# ICN ad hoc report

# Summary (original comment)

- Proposal is to change only the mated MCB/HCB ICN requirements to accommodate the 10 lane connector.
  - No changes proposed to channel or cable assembly requirements

# Mated compliance board ICN measurements

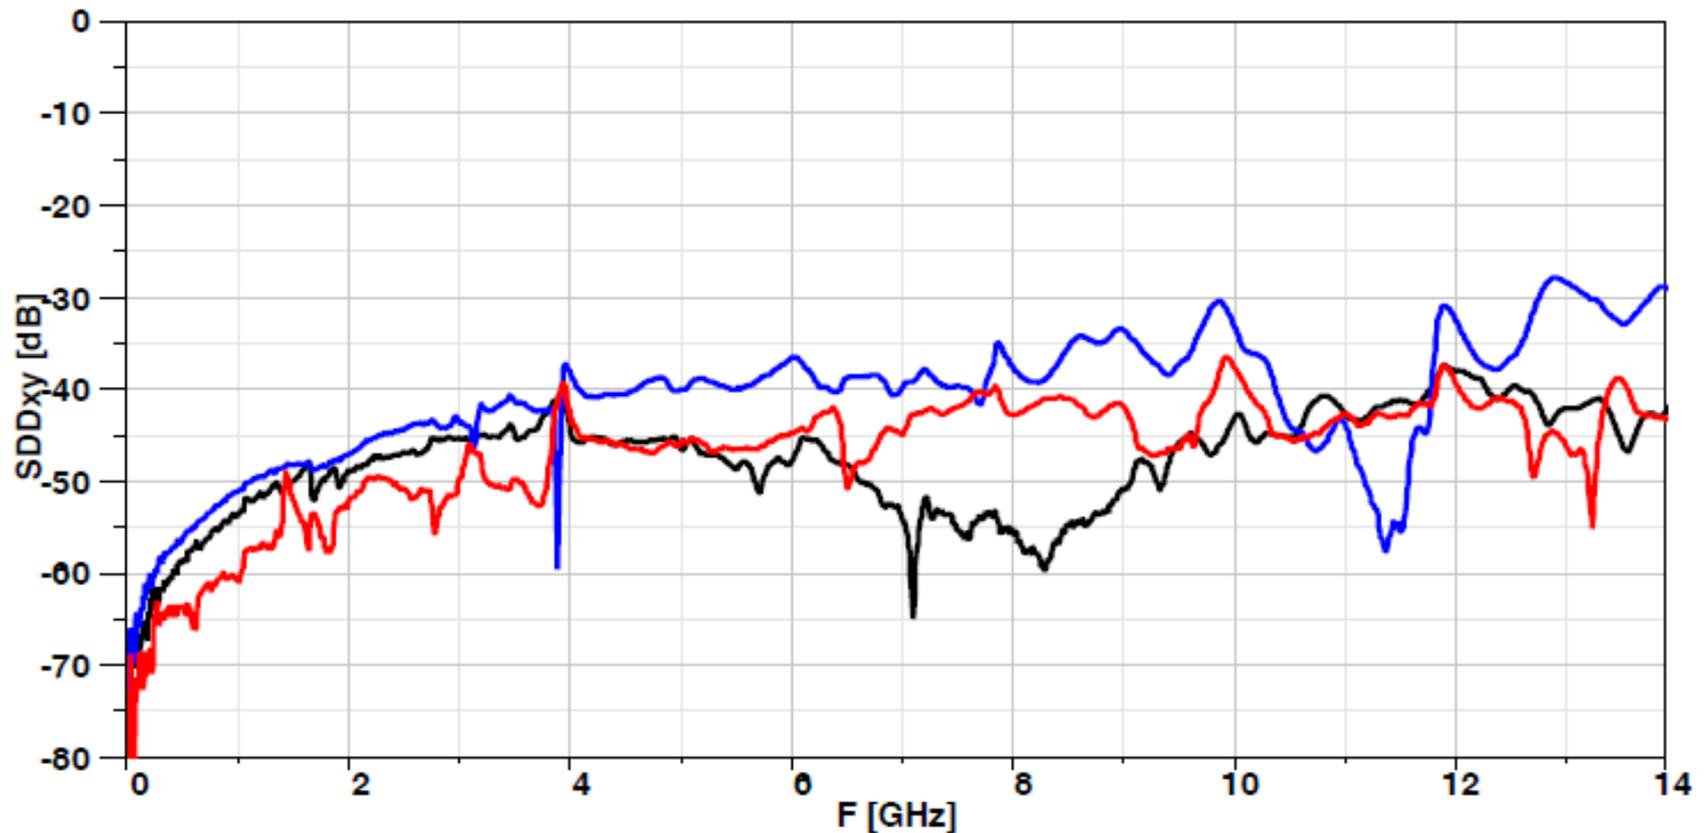
ICN settings: 10.3125Gbps 0.6V amplitude  
The ICN calculates to: 5.6mV

# Cable Assembly ICN (Includes cable assembly test fixtures)

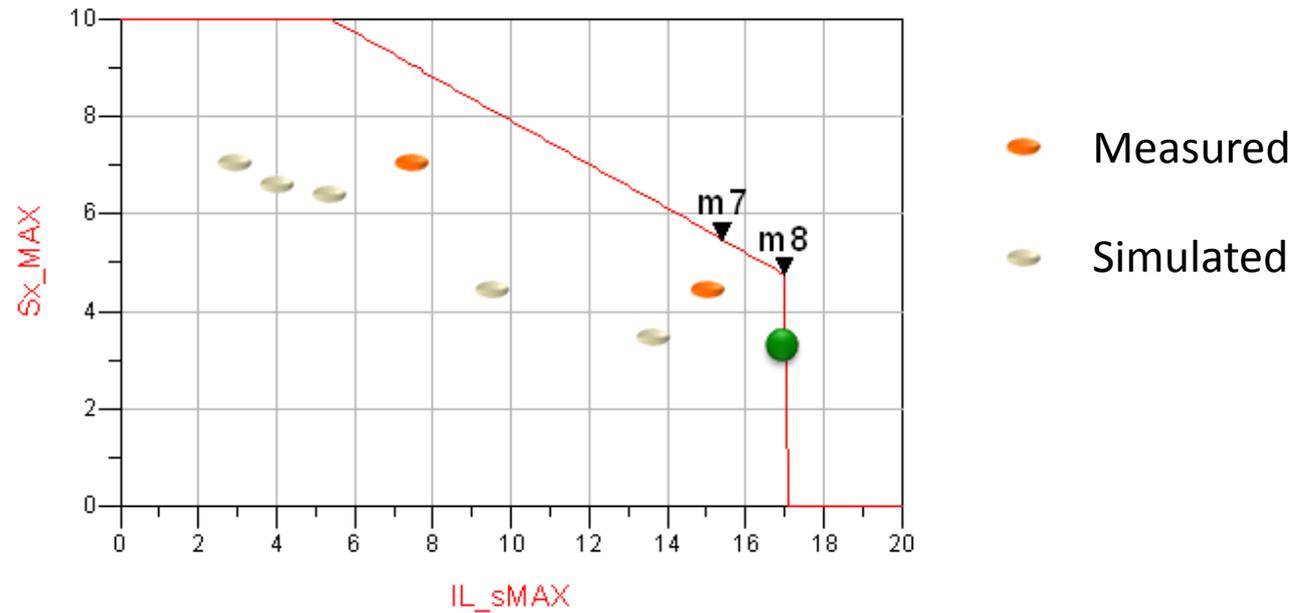
m7  
 indep(m7)=15.400  
 plot\_vs(Sx\_MAX, IL\_sMAX)=5.470

m8  
 indep(m8)=17.000  
 plot\_vs(Sx\_MAX, IL\_sMAX)=4.750
